DART AEROSPACE LTD		Work Order:	135688
Description: Crosstube Mid Fwd (206L)		Part Number:	D206-667-107
Inspection Dwg: D206-667-147 Rev: A		Page 1 of 1

DART AEROSPACE LTD HAWKESBURY, ONTARIO, CANADA	
DRAWING NO. D206-667-147	REV. A SHEET 1 OF 4
TITLE CROSSTUBE ASS'Y (206L MID FWD)	SCALE NTS
COPYRIGHT © 2010 BY DART AEROSPACE LTD THIS DOCUMENT IS PRIVATE AND CONFIDENTIAL AND IS SUPPLIED ON THE EXPRESS CONDITION THAT IT IS NOT TO BE USED FOR ANY PURPOSES OR CLAIMS OR COMMUNICATED TO ANY OTHER PERSON WITHOUT WRITTEN PERMISSION FROM DART AEROSPACE LTD.

DRAWING NO. D206-667-147	TITLE CROSSTUBE ASS'Y (206L MID FWD)	REV. A	DART AEROSPACE LTD ENGINEERING ORDER		D.E.O. NO. D206-667-147-A-1	SHEET NO. SHEET 1 OF 1	SCALE NTS
DRAWN <i>q</i>	CHECKED <i>AS</i>	MFG. APPR. <i>AS</i>	APPROVED <i>MD</i>		DE APPR. <i>MD</i>		
DATE 11.07.15	DATE 11.07.20	DATE 11.07.21	DATE 11.07.21		DATE 11.07.21

DETAIL P
BONDING STRAP INSTALLATION 2 PL

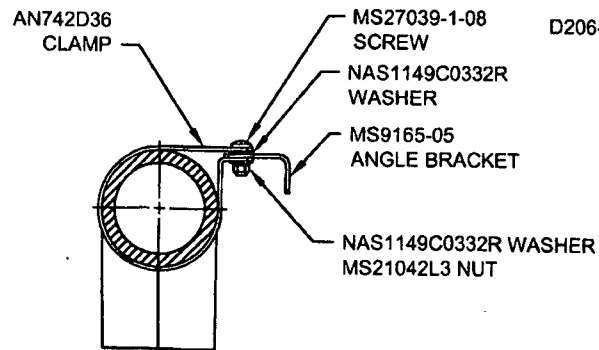
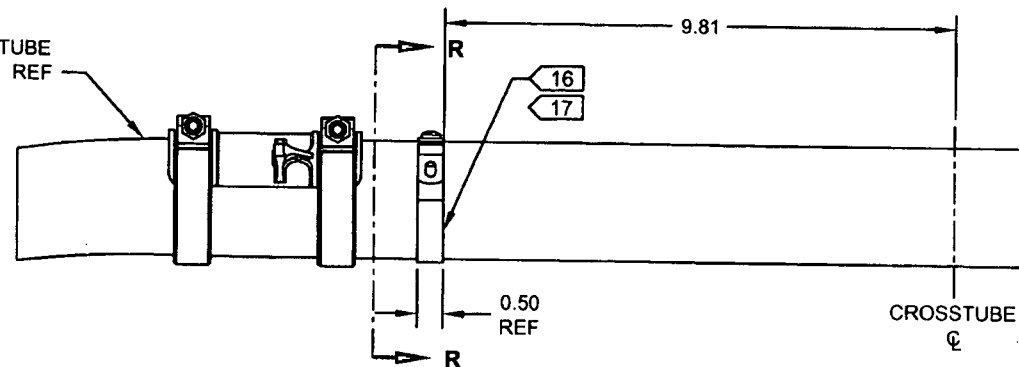
PURPOSE:

ADD ELECTRICAL GROUNDING STRAP

ITEM	QTY -147	PART NUMBER	DESCRIPTION
1	X	D206-667-147	CROSSTUBE ASSEMBLY (206L MID FWD)
⚡			
10	2	AN742D36	CLAMP
11	2	MS9165-05	ANGLE BRACKET
12	2	MS21042L3	NUT (OR MS21042-3)
13	2	MS27039-1-08	SCREW
14	4	NAS1149C0332R	WASHER (OR AN960C10L)

- 16) MASK AREA UNDER CLAMP PRIOR TO PAINTING
- 17) SEAL EDGES WHERE AN742D36 CLAMP MEETS WITH THE CROSSTUBE USING SIKAFLEX-241/-291 OR MIL-S-8802 CLASS B2 OR PROSEAL 890 SEALANT
- 18) PERFORM RESISTANCE CHECK TO ENSURE MAX RESISTANCE IS 10 MILLIOHMS
